ZONING AMENDMENT STAFF REPORT**Date: January 4, 2007****NAME**

LOCATION201 South University Boulevard
(Southeast corner of South University Boulevard and
Sunset Drive South)**CITY COUNCIL
DISTRICT**

PROPOSED ZONING

B-1, Buffer Business District

SITE PLAN

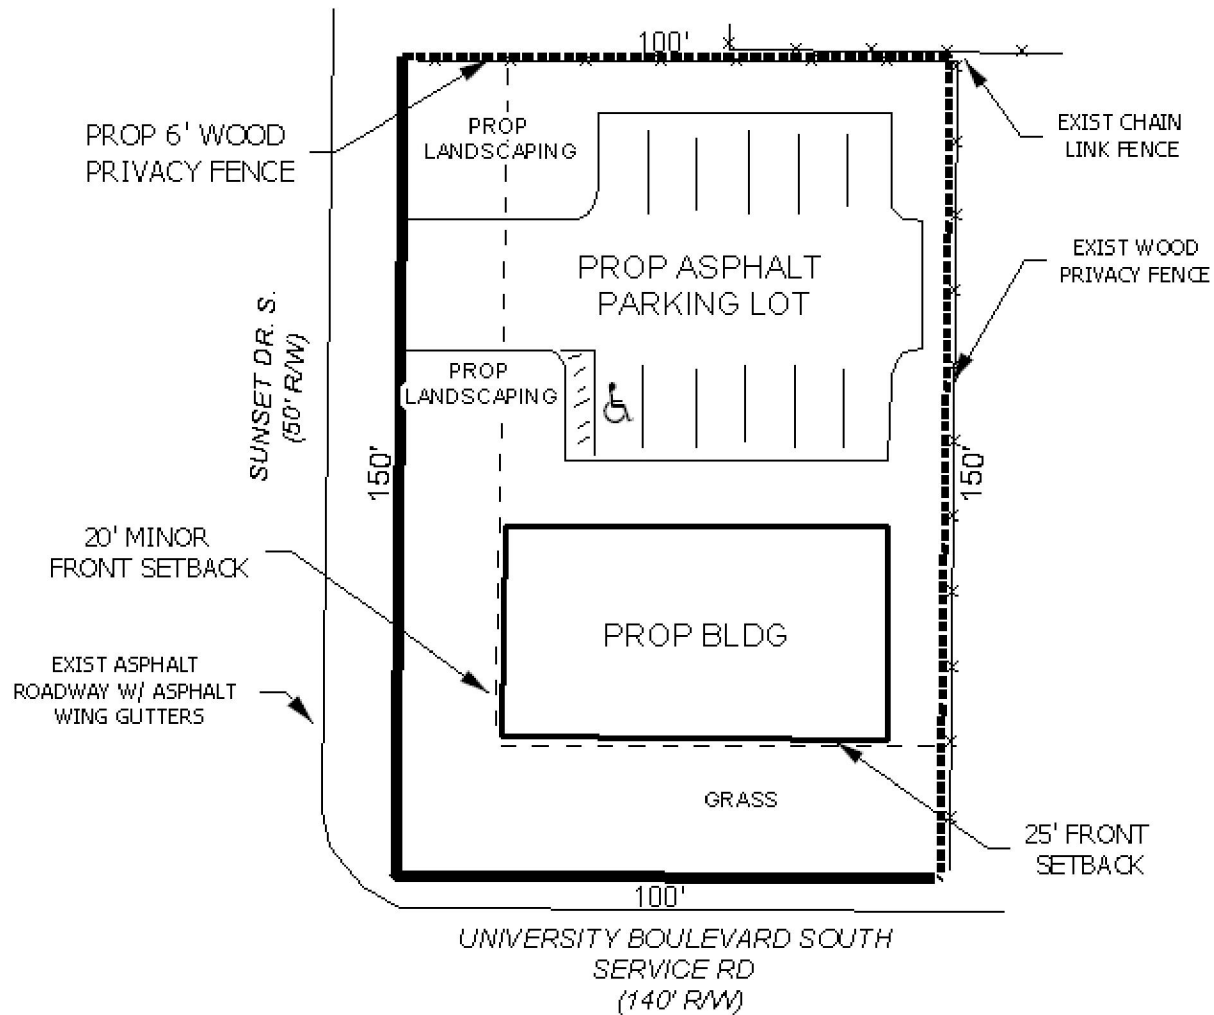
The site plan indicates that the 12-space paved parking area will access Sunset Drive South, while the proposed 2,800 square foot building will be built on the West side of the site. The site is designed so that there is sufficient space to provide buffering between the proposed commercial use and adjacent residential uses, as required by the Zoning Ordinance. The site plan is not sufficiently detailed, however, to determine if the proposed landscaping meets tree quantity requirements, or if the parking area screening required in Section 64-6.3.i. is provided (screening of parking area from adjacent residential uses, including across the street).

It should also be pointed out that section 64-4.3.c. states that parking areas containing 10 or more cars must be illuminated during the hours of operation, but that the lighting cannot shine directly into adjacent residential properties or into traffic.

Finally, no dumpster or other private waste disposal location is depicted on the site plan, thus the site plan should be revised to depict the dumpster location. The location, furthermore, should be located away from adjacent residential uses, not only in terms of protecting residences from offensive odors, but also from the noise of the dumpster being emptied during the day or night.
